### APPEAL SUMMARY

<b>Appeal ID:</b> 20263	<b>Project Address:</b> 1715 SW Salmon St
<b>Hearing Date:</b> 4/17/19	<b>Appellant Name:</b> John Smith
<b>Case No.:</b> B-012	<b>Appellant Phone:</b> 503.445.7350
<b>Appeal Type:</b> Building	<b>Plans Examiner/Inspector:</b> Brian McCall, Joe Thornton
<b>Project Type:</b> commercial	<b>Stories:</b> 8 <b>Occupancy:</b> R-2, A,B,S <b>Construction Type:</b> I-A, III-A
<b>Building/Business Name:</b> 18S	<b>Fire Sprinklers:</b> Yes - Full NFPA 13
<b>Appeal Involves:</b> Erection of a new structure	<b>LUR or Permit Application No.:</b> 19-106743-CO
<b>Plan Submitted Option:</b> pdf [File 1]	<b>Proposed use:</b> mixed use housing

<b>Code Section</b>	202, High-Rise Building Measurement
<b>Requires</b>	Section 202 defines a high-rise building as "a building with an occupied floor located more than 75 feet about the lowest level of fire department vehicle access".
<b>Proposed Design</b>	<p>The project is being developed in concert with TriMet and the City of Portland to create a transit-oriented development at this long-underutilized site in Goose Hollow. The site is adjacent to the Kings Hill Max Station, along SW Salmon Street between SW 17th

**HIGH RISE DEFINITION - SECTION 202 OSSC**

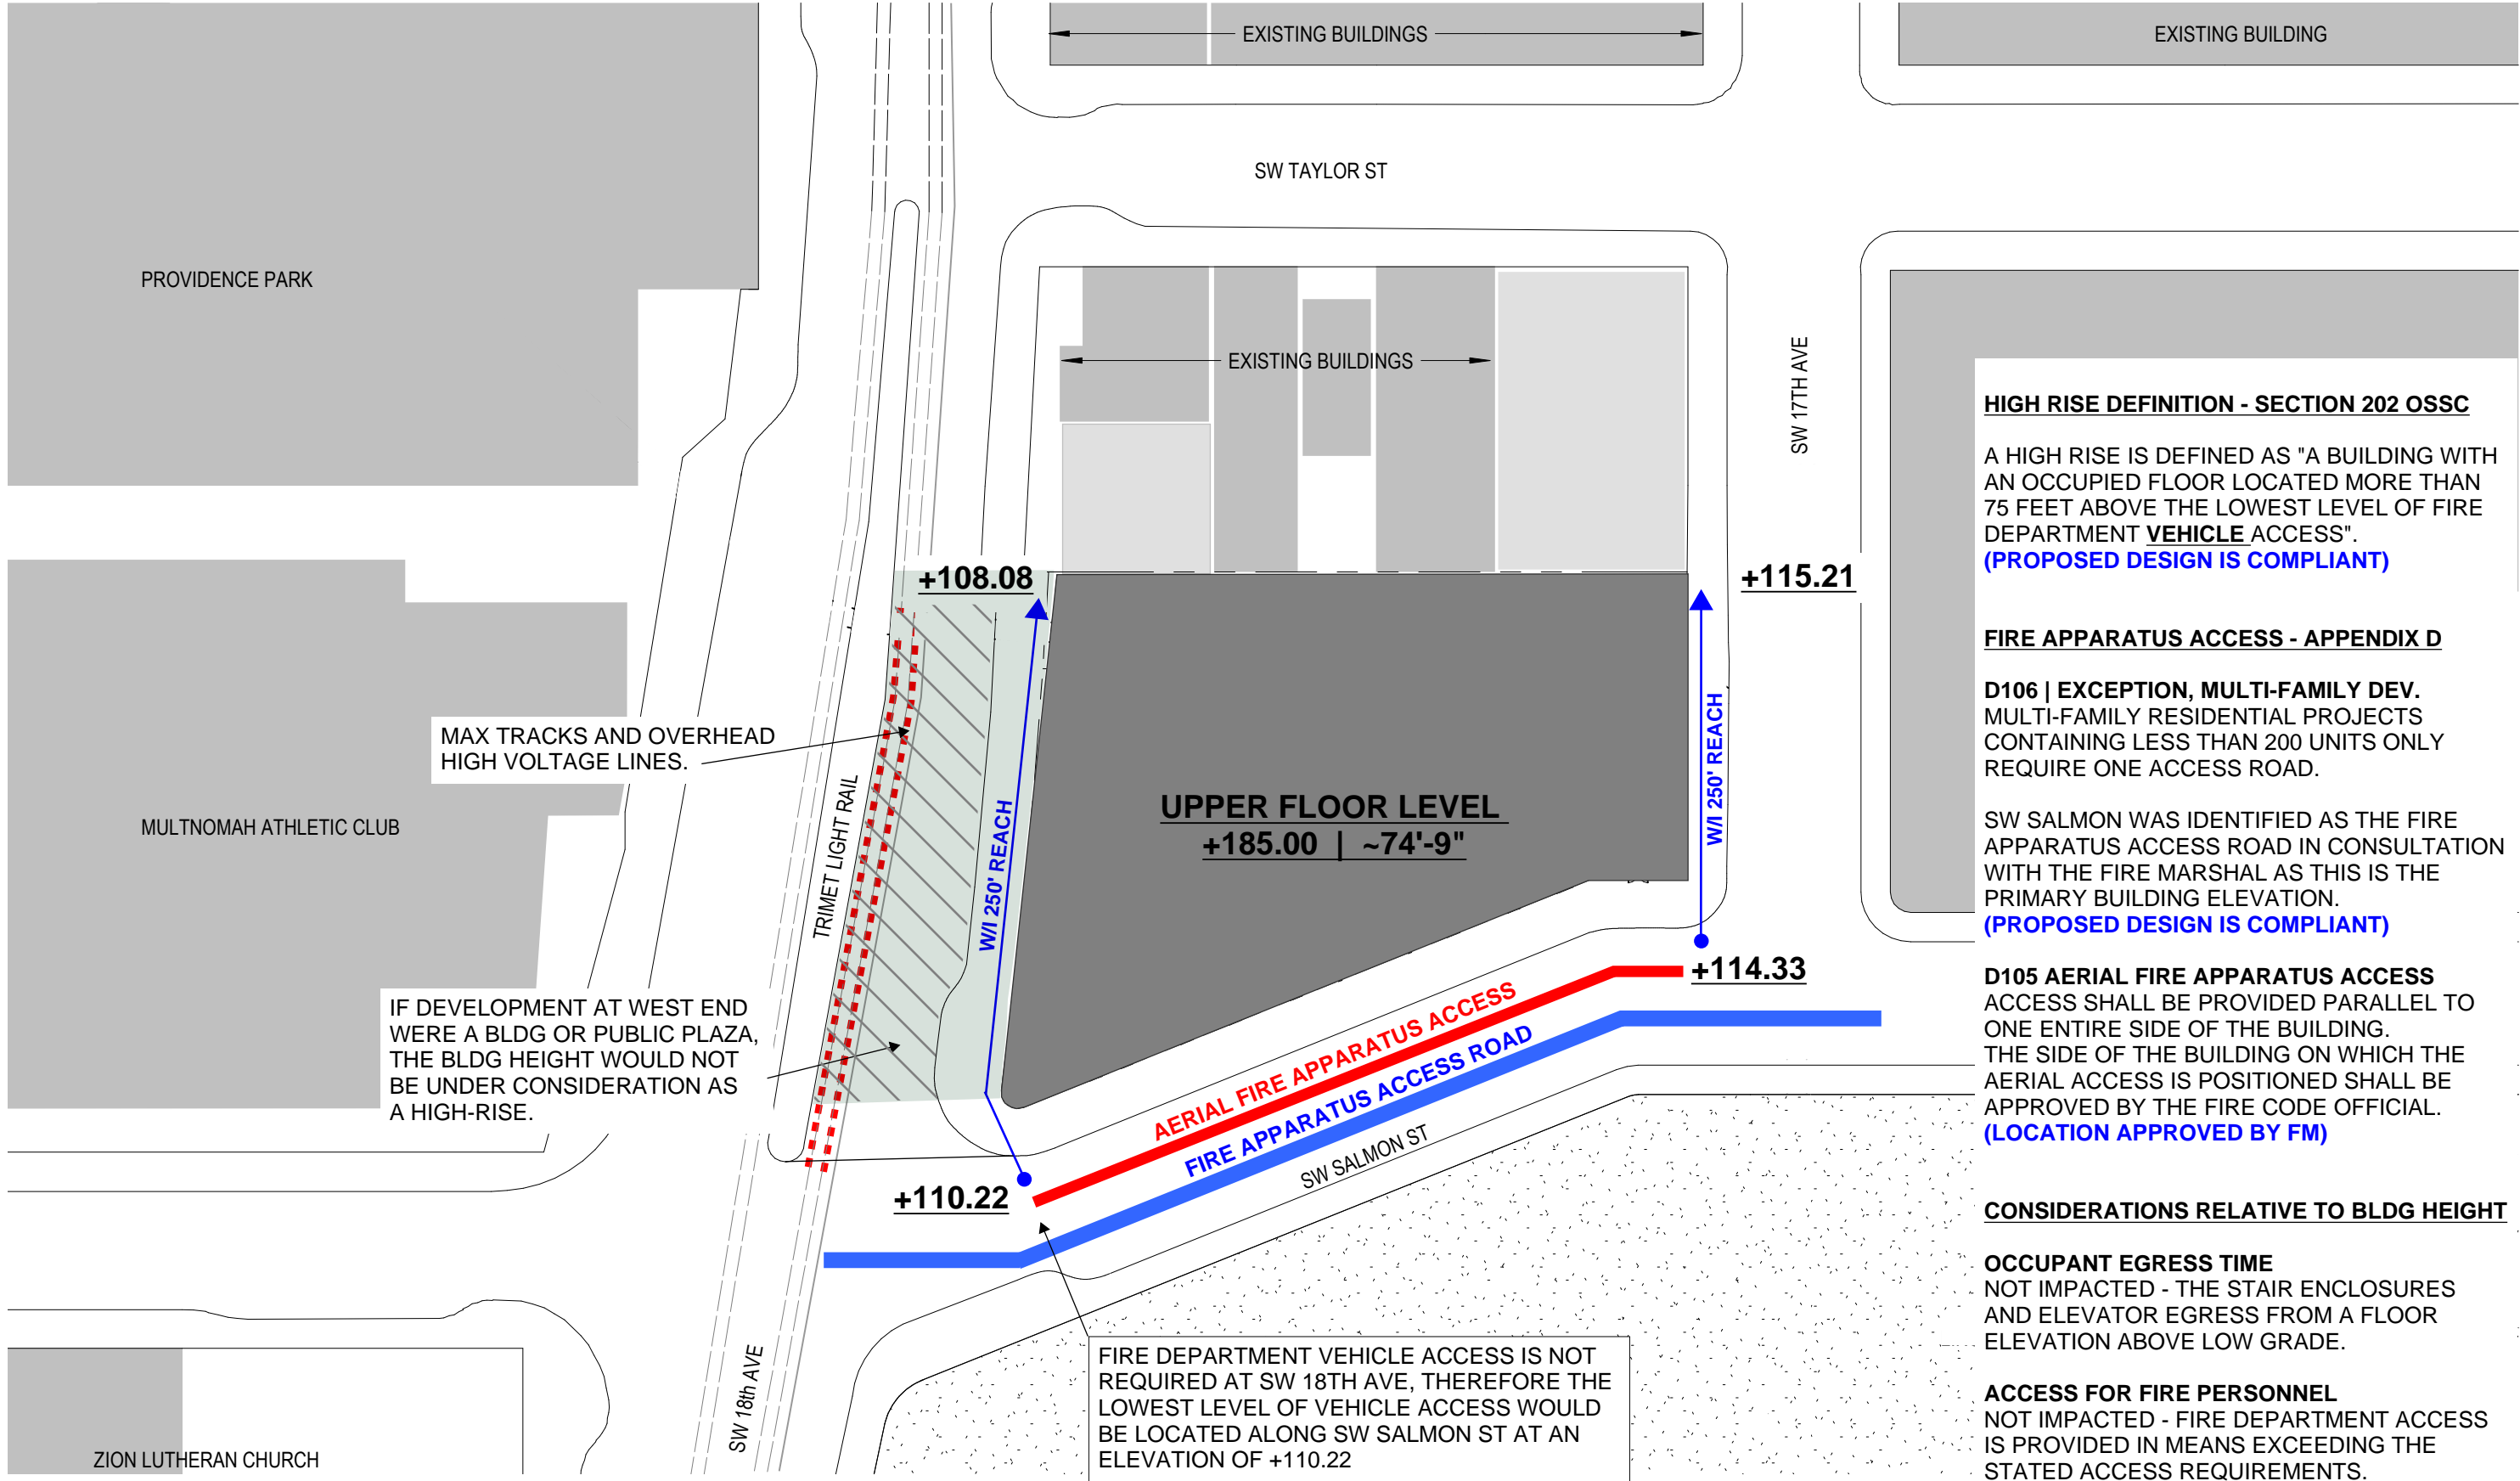
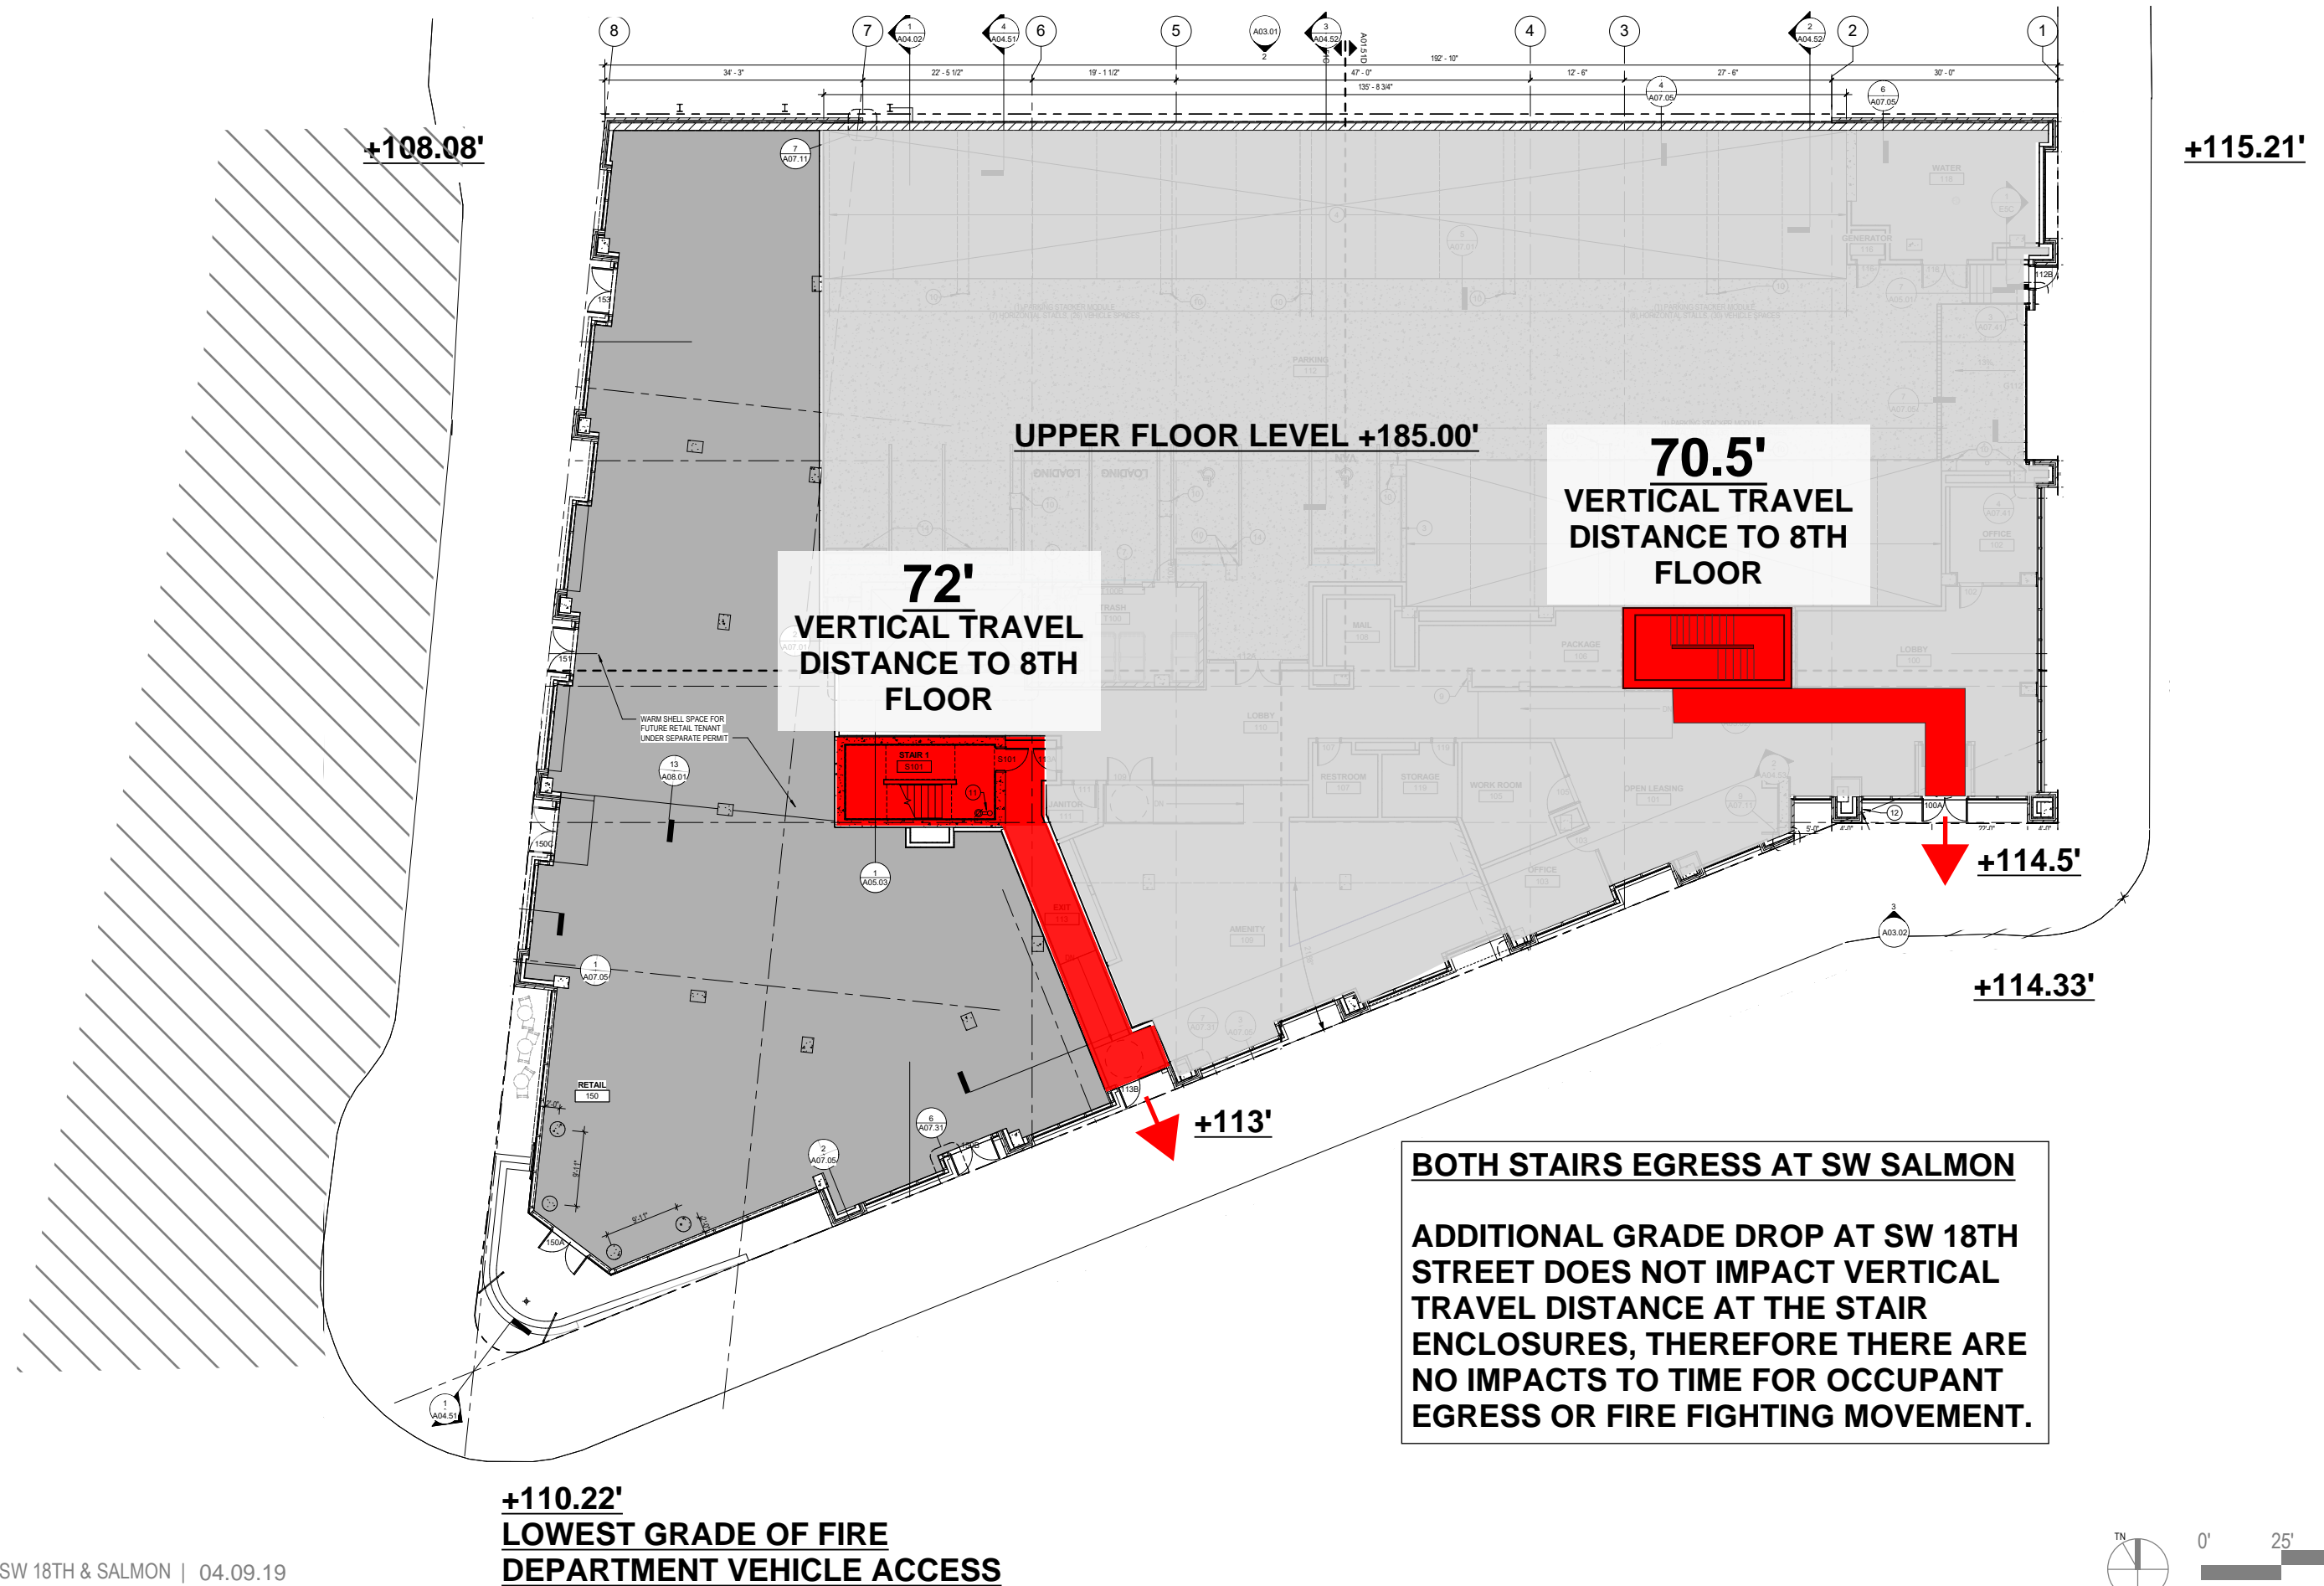
**1. Determination of the lowest point for calculating the lowest level of fire department vehicle access: Denied. Proposal does not provide equivalent Life Safety protection.**
